SOUTH WAIRARAPA DISTRICT COUNCIL

29 JANUARY 2014

APPLICATION FOR SWIMMING POOL FENCE EXEMPTION – 3 EAGLE PLACE, MARTINBOROUGH

Appendix 1 – Plan of Application for 3 Eagle Place, Martinborough

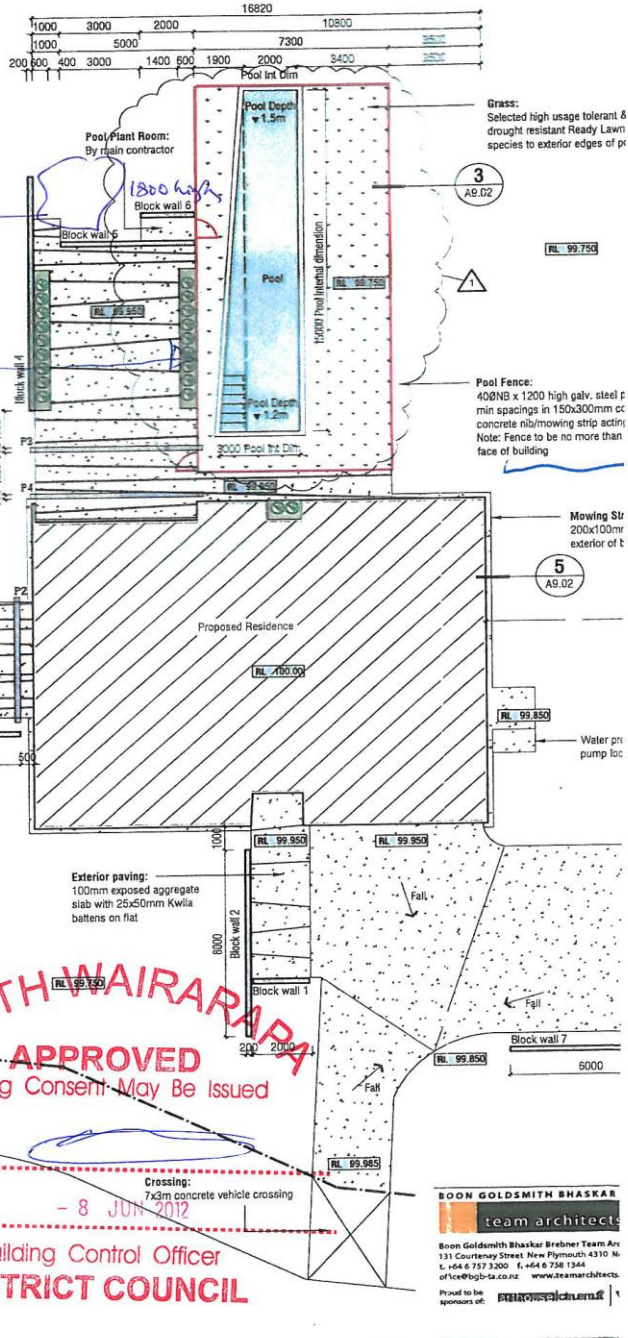
An application has been received from Mr Mark Hadlow for an exemption to the Fencing of Swimming Pools Act. He wishes approval to use a manually operated sliding door (access from the dwelling) as part of the pool fence, at 3 Eagle Place, Martinborough. The property is residential.

The inclusion of the house (and therefore manually opened and closed sliding door) as part of the fence, is an amendment to their original swimming pool design that showed a fully compliant swimming pool fence around the pool (see site plan Appendix 1).

In making a decision about whether a non-self closing and self latching sliding door is a sufficient alternative to a fence, the Council must decide the likelihood of a door being locked whenever the pool is not in use and consider the consequences if the door failed to provide a sufficient barrier to young children because it was left open.

Where a sliding door is not self-closing the reliance is solely on the owner to ensure the door remains closed and latched to prevent young children from entering the pool area. A self-closing door would mean if someone steps away from the pool, the barrier and door automatically prevents a child accessing that pool.

1. *Receives the information.*
2. *Decline the application for exemption to fence a swimming pool at 3 Eagle Place, Martinborough under Section 6 of the Fencing of Swimming Pools Act 1987*

There is always a risk with approving any exemption under the Fencing of Swimming Pools Act 1987 and allowing a pool to have a non-complying barrier or fence. The difficulty is in determining whether the increase in risk is significant or not. To ensure a consistent approach and to best manage the risk to young children, officers recommend that Council decline this application.
